| <b>Project:</b>   | Roydon Quarry                                     | <b>Document No.:</b>    | Ca 004 R01          |                     |    |
| <b>Subject:</b>   | Response to Further Information Request           |                         |                     |                     |    |

Figure A: Daily average noise level profile

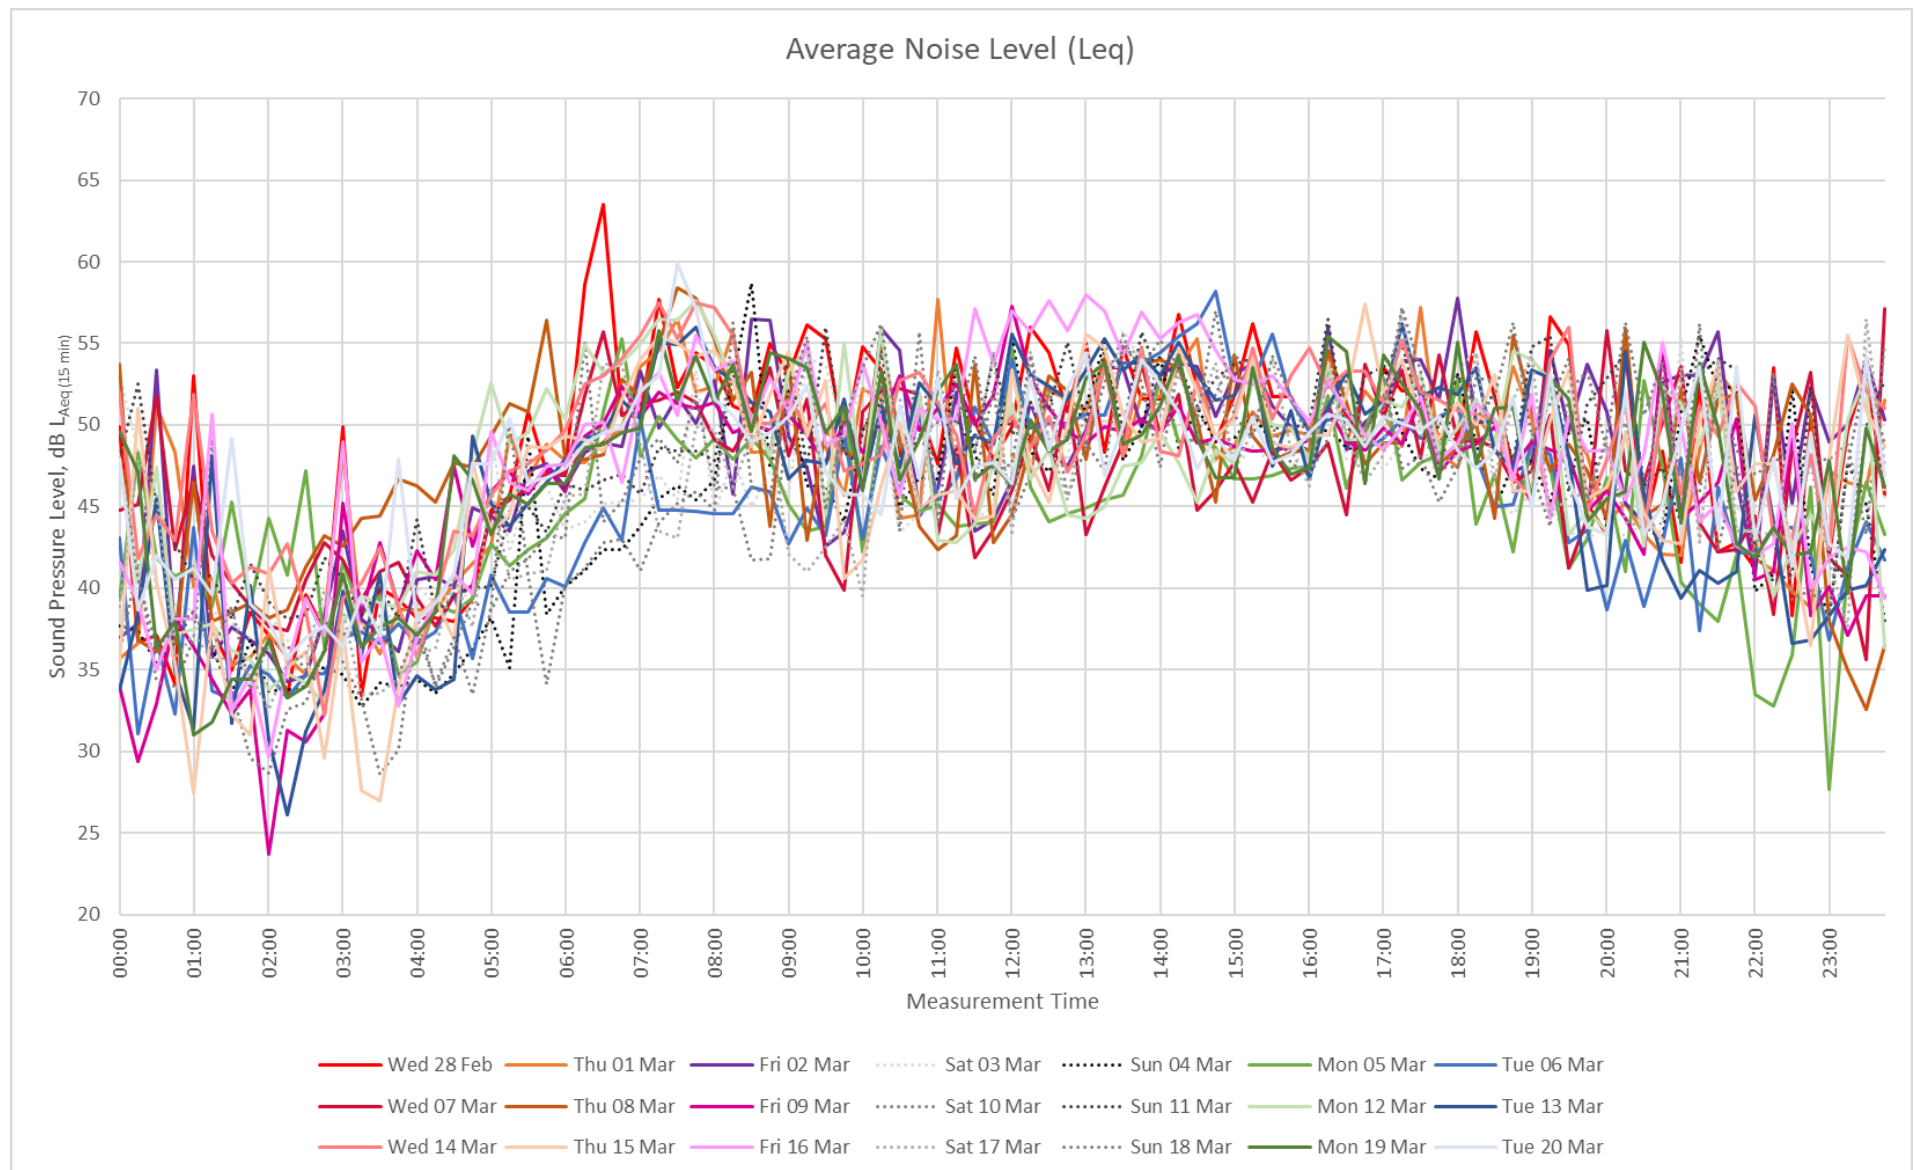
4. *Could MDA please provide a figure similar to E2 in Appendix E which shows the daily LAeq and LAFmax levels. It is difficult to read this information from figure E1 provided.*

Please find the requested figures appended to this document as Figure A (L<sub>eq</sub>) and Figure B (L<sub>max</sub>).
